REMARKS

This amendment is in response to the Official Action dated May 2, 2005. The drawings and specification have been amended. Claims 1, 6, 9, 14, 15, 16 and 18 have been amended, Claims 5, 12, 13 and 17 have been cancelled and new Claim 21 has been added. The application now includes Claims 1-4, 6-11, 14-16 and 18-21 with Claims 1, 9 and 16 being the only independent claims. Favorable reconsideration, in view of the above amendments and accompanying remarks, is respectfully requested.

AMENDMENTS TO THE DRAWINGS

FIG. 2
PRIOR ART

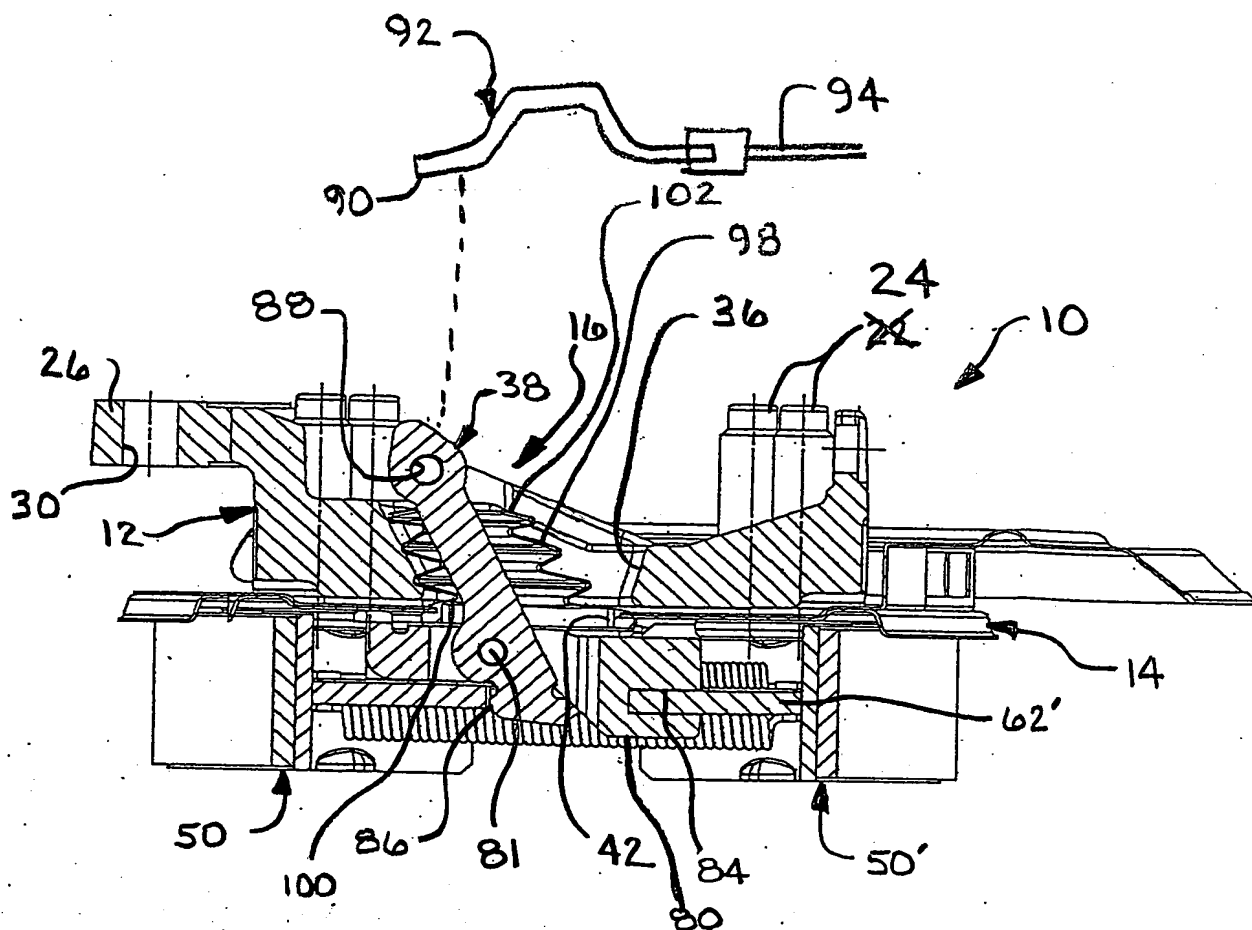
Please amend the drawings as follows: drawing Fig. 2 by changing reference character 22 to 24 and adding reference character 81; drawing Fig. 3 by adding reference character 138; and drawing Fig. 4 by adding arrow and label “pulling direction”, as shown in red on the attached drawing sheets. Attached herewith are “Replacement Sheets” of Figs. 2, 3 and 4 and “Annotated Marked-Up Drawings” of Figs. 2, 3 and 4. No new matter has been added. Formal drawings will be submitted upon approval of these changes and issuance of a Notice of Allowance.
